PRODUCT/PROCESS CHANGE NOTICE (PCN)

PCN #: TB-0609-02 DATE: 06-Oct-2006 Product Affected: SOJ 28L, 32L, 36L Products shipped in tube Date Effective: 06-Jan-2007	MEANS OF DISTINGUISHING CHANGED DEVICES: <input type="checkbox"/> Product Mark <input type="checkbox"/> Back Mark <input type="checkbox"/> Date Code <input checked="" type="checkbox"/> Other Rev. 08 printed on shipping tube
-----------------------------------------------------------------------------------------------------------------------------------------------------------------------	-------------------------------------------------------------------------------------------------------------------------------------------------------------------------------------------------------------------------------------------------------------------------

ATTACHMENT I - PCN #: TB-0609-02

TITLE: PB/PBG 28/32/36 SHIPPING TUBE

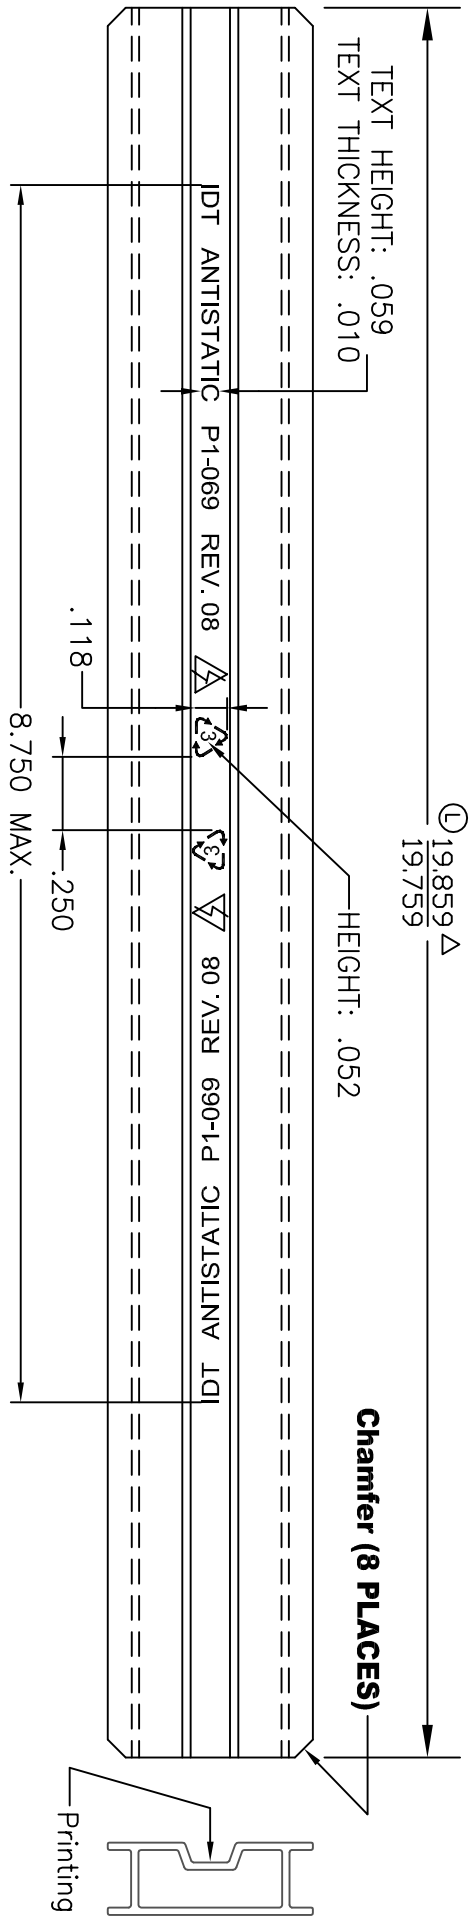
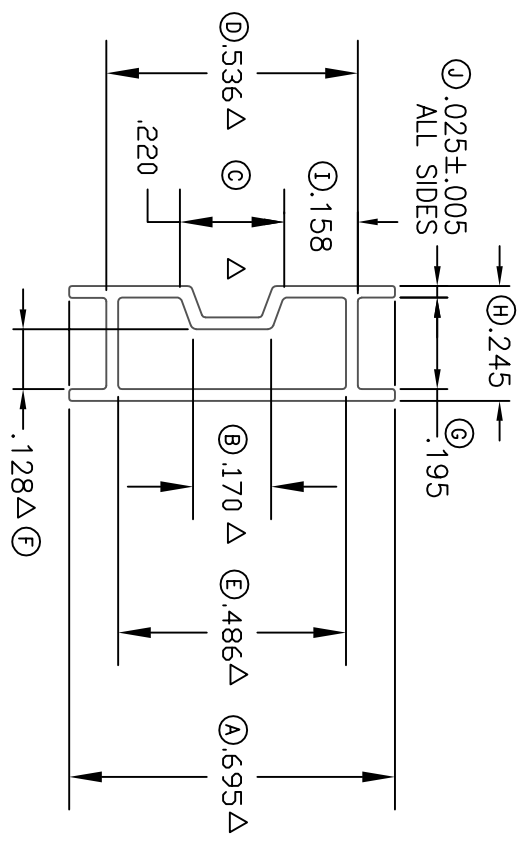
Detail of Change: This notification is to advise our customer that IDT has qualified new shipping tubes for SOJ 28L, 32L, 36L products. The new shipping tubes have an increase in the tube opening height from 0.105 inches to 0.128 inches to provide better protection for packages during assembly, test and backend processes.

** Note: Tube opening height is denoted as dimension 'F' in the tube drawing. See attachment for the drawing.*

REVISIONS				
REV	DESCRIPTION	DATE	APPROVED	
13	INCLUDED ITW MERITEX AS SUPPLIER	03/11/06	KK Three	
14	INCREASE (F) FROM 0.105" TO 0.128"	08/24/06	KK Three
